HISTORIC AND DESIGN REVIEW COMMISSION

May 16, 2018

HDRC CASE NO: 2018-208
ADDRESS: 802 NOLAN
LEGAL DESCRIPTION: NCB 563 BLK 7 LOT W102.6 FT OF 1 AT 802 NOLAN
ZONING: R-6
CITY COUNCIL DIST.: 2
DISTRICT: Dignowity Hill Historic District
APPLICANT: Jenny Hernandez
OWNER: Mike O'Neal
TYPE OF WORK: New Construction - Conceptual
APPLICATION RECEIVED: April 30, 2018
60-DAY REVIEW: June 29, 2018

REQUEST:

SITE PLAN

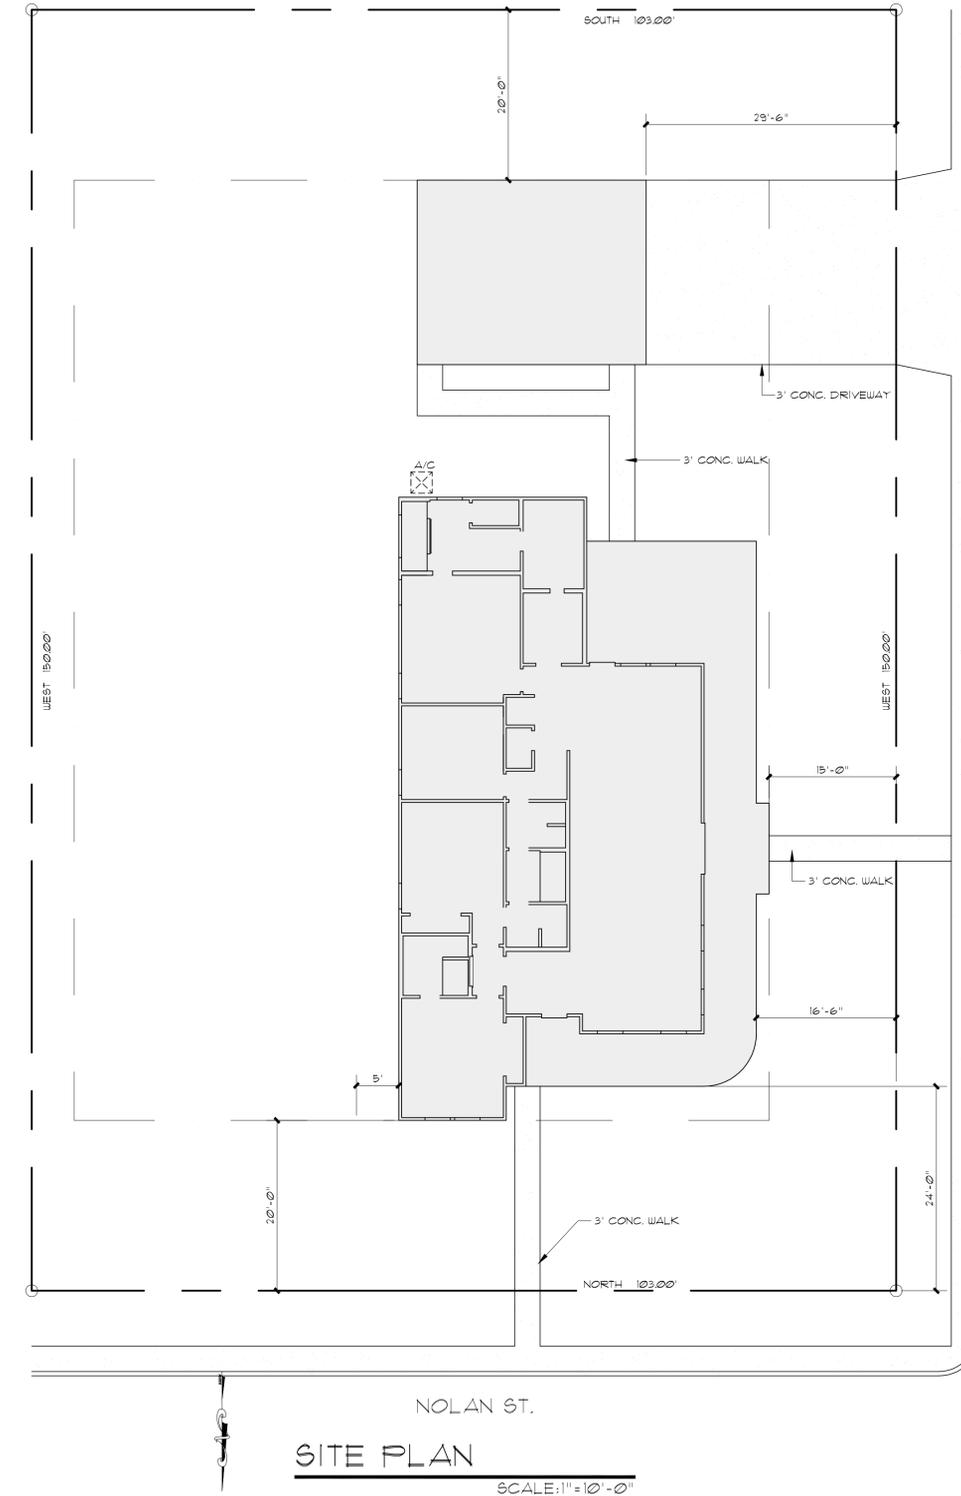
- c. **SETBACKS & ORIENTATION** – According to the Guidelines for New Construction, the front facades of new buildings are to align with front facades of adjacent buildings where a consistent setback has been established along the street frontage. Additionally, the orientation of new construction should be consistent with the historic examples found on the block. The applicant has noted a setback of twenty (20) feet from the front property line; however, the applicant has not specified the setback from the street.

- n. DRIVEWAY – The applicant has proposed a driveway to feature a curbcut and total width of approximately twenty (20) feet. The Guidelines for Site Elements 5.B.i. notes that driveways should not exceed more than ten (10) feet in width. Staff finds that two ribbon strip driveways rather than one continuous concrete surface may be most appropriate at this location.

- i. That the applicant ensure that a setback is proposed that is deeper than that of the neighboring historic structures on the block as noted in finding c.

- vii. That the proposed driveway be separated into ribbon strips to prevent a continuous concrete slab from being installed.
- viii. That the rear garage feature metal or wood doors.

FRONT ELEVATION
SCALE: 1/4" = 1'-0"

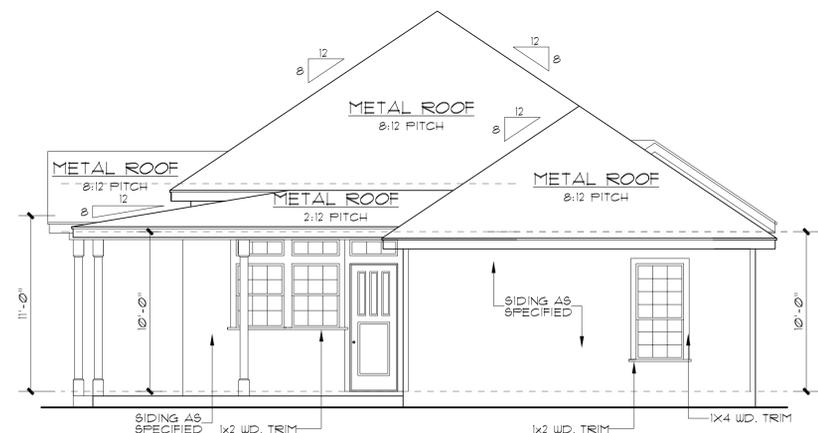
- d. **ENTRANCES** – According to the Guidelines for New Construction 1.B.i., primary building entrances should be oriented towards the primary street. The proposed entrance is appropriate and consistent with the Guidelines.

- h. **WINDOW & DOOR OPENINGS** – Per the Guidelines for New Construction 2.C.i., window and door openings with similar proportions of wall to window space as typical with nearby historic facades should be incorporated into new construction. Generally, the applicant has proposed window and door openings that are consistent with the Guidelines in regards to locations and profiles. Staff finds that the inclusion of transom windows above each window openings is inconsistent with fenestration patterns found throughout the district and should be eliminated. Additionally, staff recommends that a window be added into bedroom 2, to prevent a front, side wall that does not include a window opening. Staff also recommends that the proposed transom window above the front door feature one single lite instead of the proposed three lites.

- k. **PORCH DESIGN** – The applicant has proposed a wraparound porch to intersect a protruding front bay with a gabled roof on the front façade and to span the entire length of the side façade, terminating at a covered patio. The applicant has proposed for the porch roof to feature a shed roof with an 8:12 roof pitch. Additionally, the applicant has proposed eight inch square porch columns with capital and base trim. Generally, staff finds the proposed porch design to be appropriate. Upon returning to the HDRC for final approval, the applicant is to provide staff with a column detail.

- iv. That the applicant eliminate transom windows above full height windows.
- v. That sidelites be added to the proposed double door on the N Olive elevation and that the proposed transom windows do not feature divided lites.

RIGHT ELEVATION

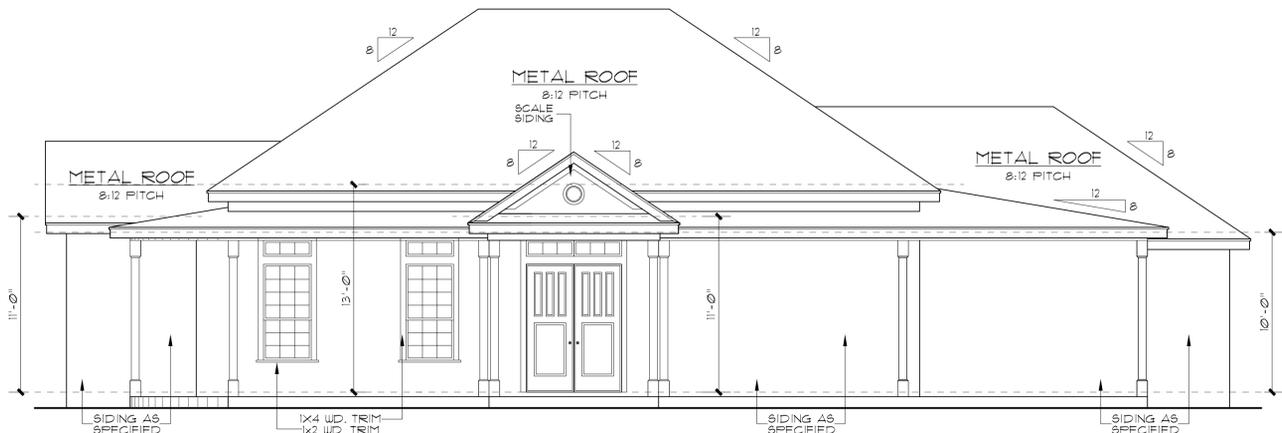
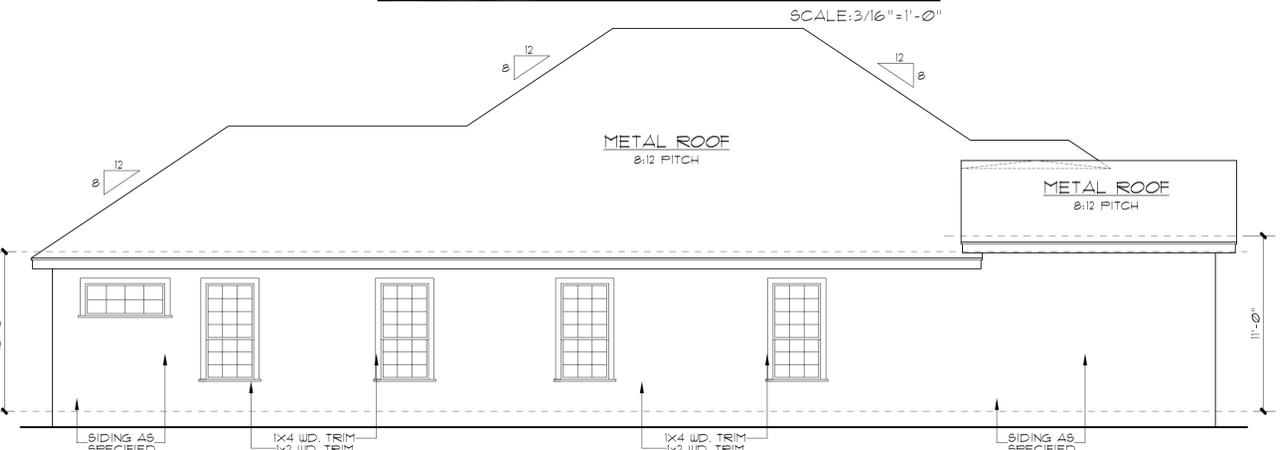
- i. **MATERIALS** – The applicant has proposed materials that include composite siding, a metal roof and aluminum clad wood windows. Staff finds that the composite siding should feature a smooth finish and a four (4) inches exposure. Additionally, the proposed roof should feature panels that are 18 to 21 inches in width, seams that are 1 to 2 inches in height, a crimped ridge seam and a standard galvalume finish.

- ii. That the applicant ensure that a foundation height of at least one (1) foot is used as noted in finding f.
- iii. That the applicant add additional fenestration to locations currently featuring blank walls.

GARAGE FRONT ELEVATION
SCALE: 1/4" = 1'-0"

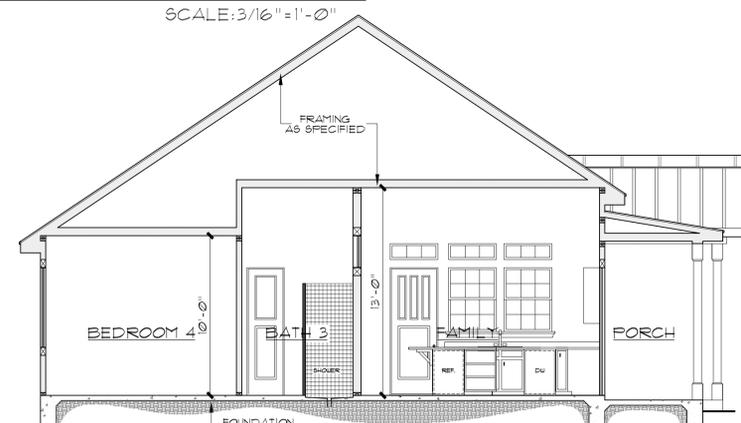
- m. **REAR GARAGE** – At the rear of the proposed new construction, the applicant has proposed to construct a two

car, detached garage. Generally, the proposed footprint and form of the garage is appropriate.
